IEEE802.3cg TF
TIS baseline amendments
November 22th, 2017

PCS Receive State Machine amendments

PLCA DATA State Machine amendments

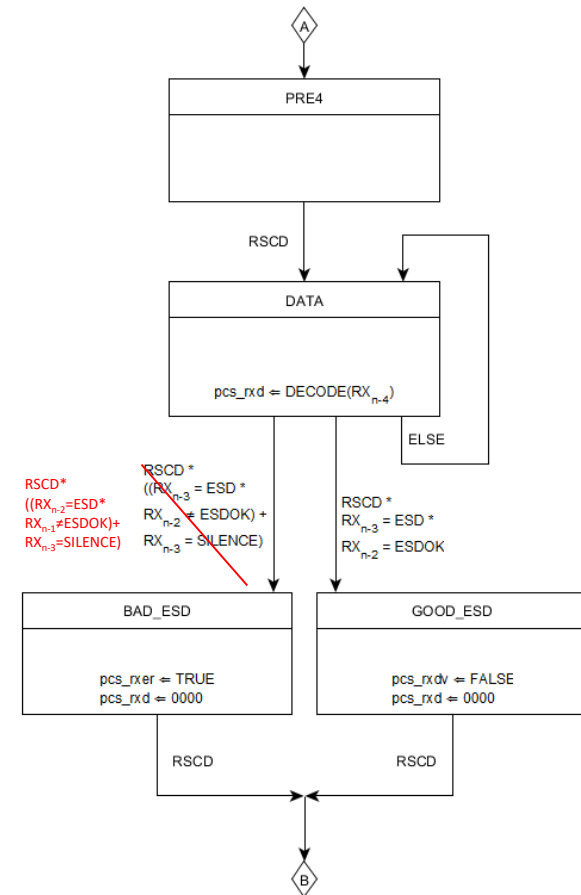
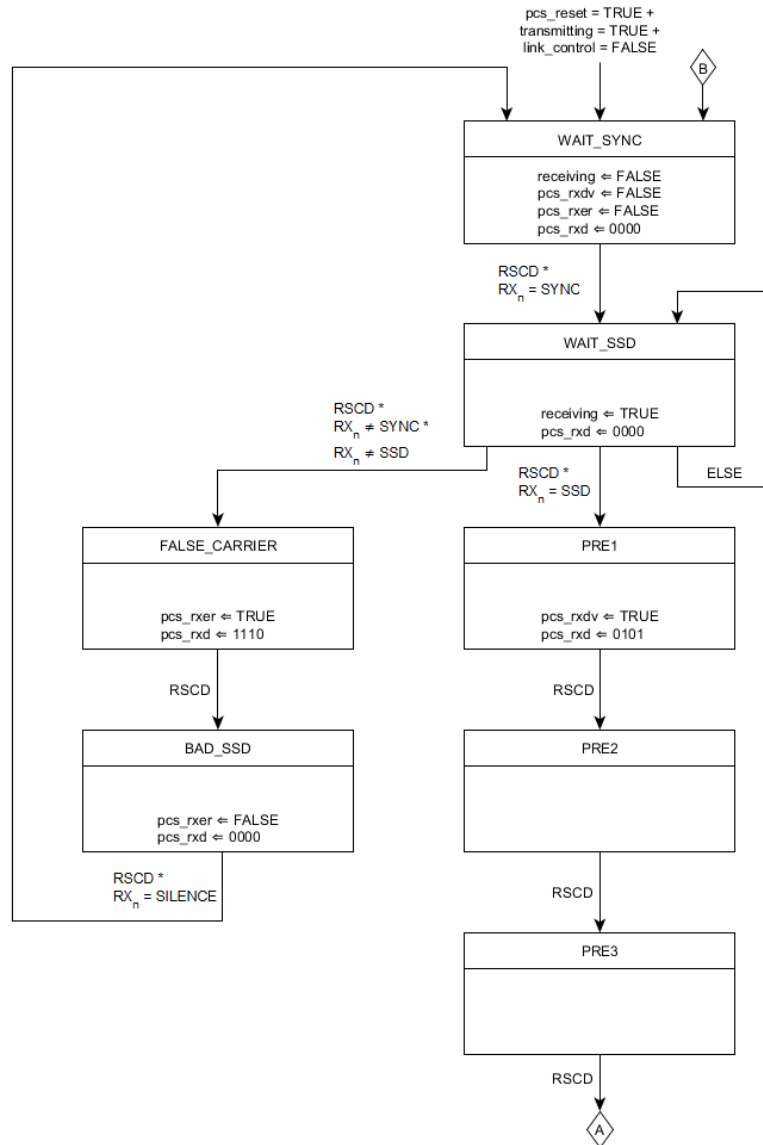
Where	What	Why
IDLE->RECEIVE RECEIVE->IDLE	state transition is triggered on “receiving”, instead of “PMA_CARRIER.Indication”	BEACON shall not trigger a state change
HOLD state	CRS = TRUE	CRS = FALSE might trigger aCarrierSenseErrors counting in MAC statistics (see 5.2.2) during logical collisions
TRANSMIT state	CRS = TRUE	CRS shall not be set to FALSE when entering TRANSMIT state from HOLD state
FLUSH state	CRS = TRUE	pcs_crs would be TRUE anyway

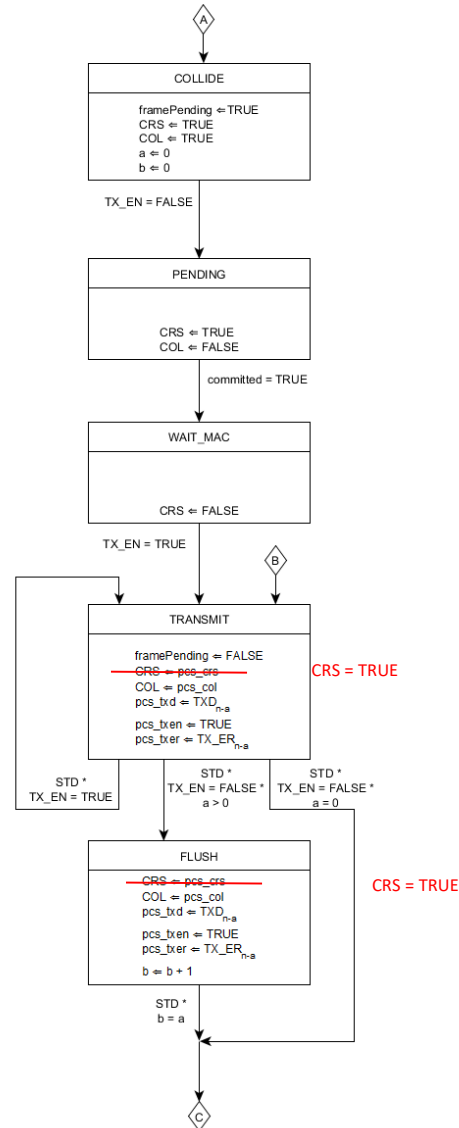
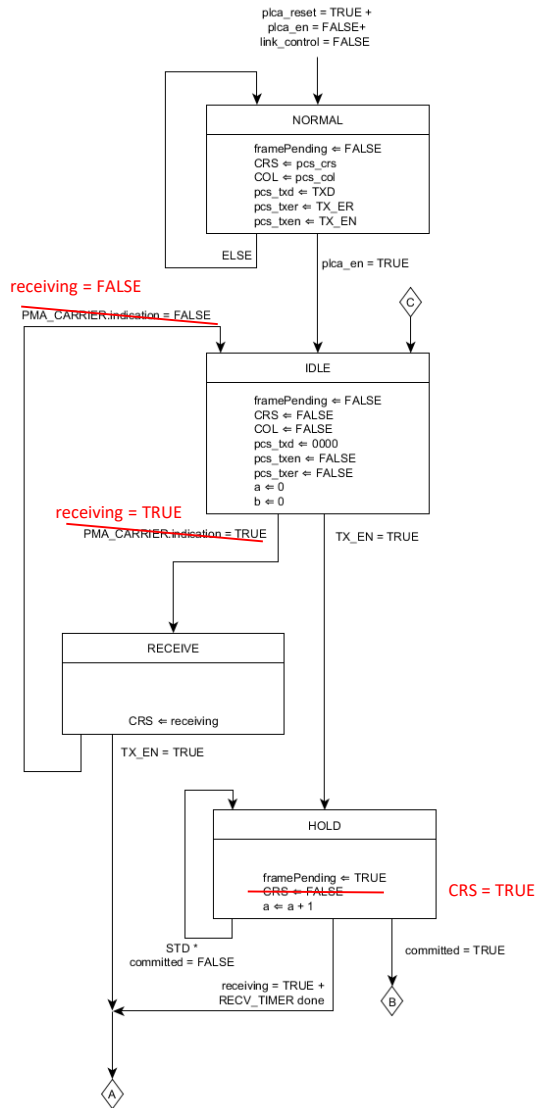
Where	What	Why
DATA -> BAD_ESD	detection of ESDERR anticipated by 1 RSCD	RX_ER shall be generated on the last valid data nibble. Otherwise an alignment error (odd number of nibbles) is reported by the MAC.
